American Rivers ♦ Audubon Mississippi ♦ Healthy Gulf
National Audubon Society ♦ Sierra Club ♦ Sierra Club Mississippi

Comments on the
Draft Supplement No. 2 To The 1982 Yazoo Area Pump Project Final
Environmental Impact Statement (October 2020)

November 30, 2020

Figure 2, 2019 Flood Inundation Map With and Without the Pumps

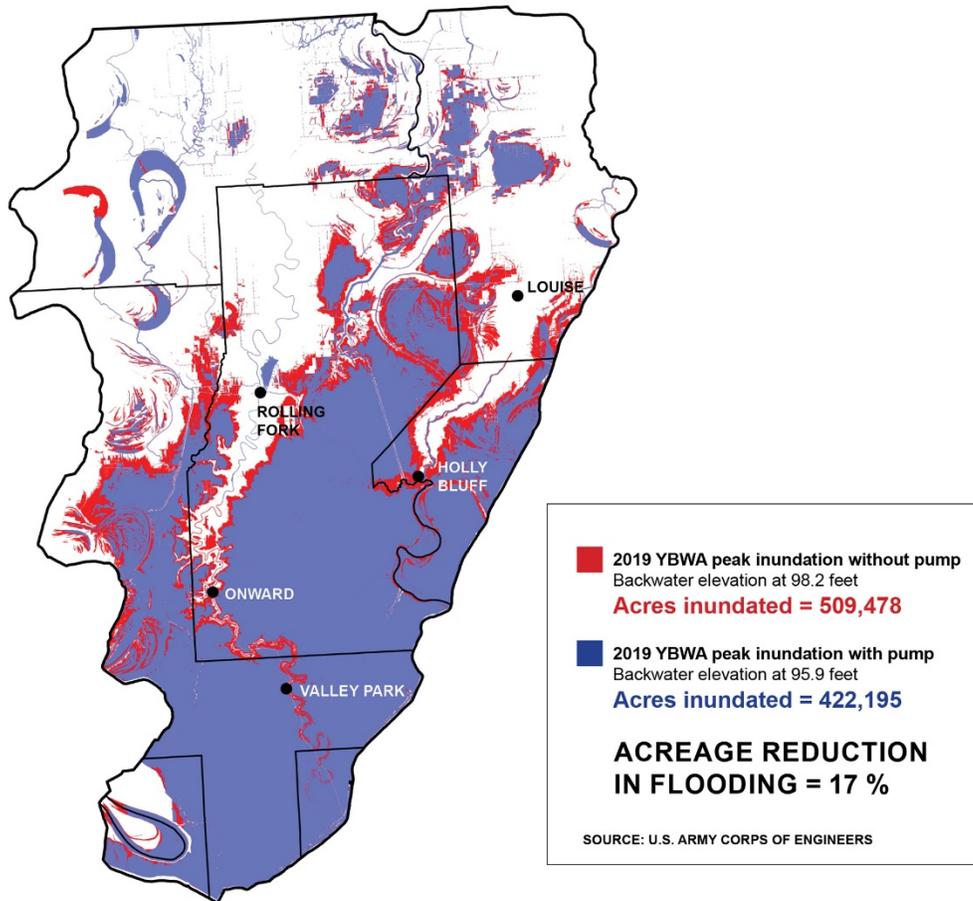
Even when the Pumps are operating, the Proposed Plan would leave 82% to 89% of flooded lands underwater and take weeks to months to drawdown floodwaters on the remaining lands.¹¹⁵

For example, had the Yazoo Pumps been in operation during the 2019 flood, 442,195 acres—**83% of the lands that flooded in 2019**—would still have been underwater, based on data provided by the Corps.¹¹⁶ Just 17% of the acreage that flooded in 2019 would have been drained by the Yazoo Pumps.

Figure 13, Completed Construction at Steele Bayou Location from USACE Presentation to EPA, Yazoo Backwater Project Brief Region IV 15 May 2019

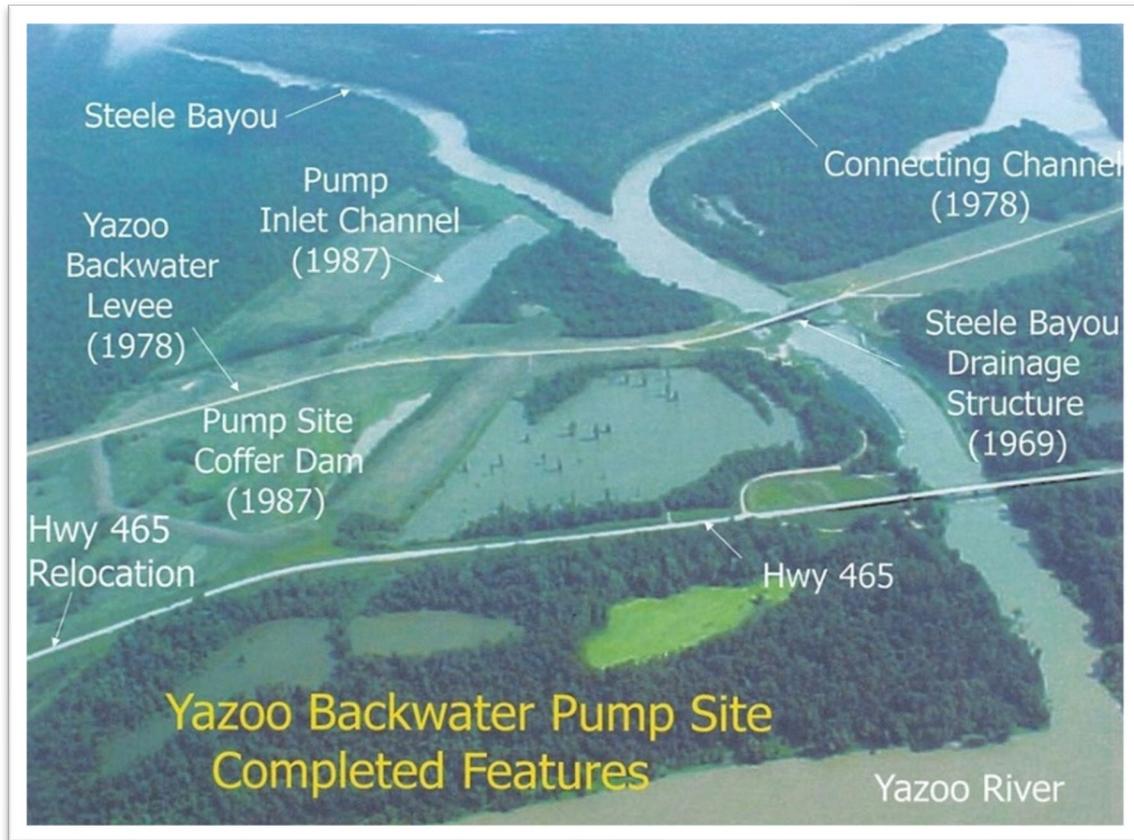
component of the Yazoo Pumps project **if** the Pumps are located at Steele Bayou. The already-constructed entrance and exit channel and cofferdam could serve no purpose whatsoever for the Yazoo Pumps—and will not be a component of the Yazoo Pumps project—if the Pumps are moved to the Deer Creek location. See Figure 13, below.⁴⁰⁰ As a result, the date of the award of the contract for these components would no longer act to waive the non-federal cost share requirement.

In short, if the Yazoo Pumps are moved to the Deer Creek location, the project could not proceed unless a non-federal sponsor could provide the non-federal cost share of 35% of total project costs (including mitigation). So, for example, if it costs \$440 million to build the Yazoo Pumps at the Deer Creek location, the non-federal sponsor would be required to contribute \$154 million of those costs, plus all necessary lands, easements, and rights of way. If construction costs increase, the costs to the non-federal sponsor would also increase since the non-federal cost share is based on a percentage of total project costs (including mitigation).
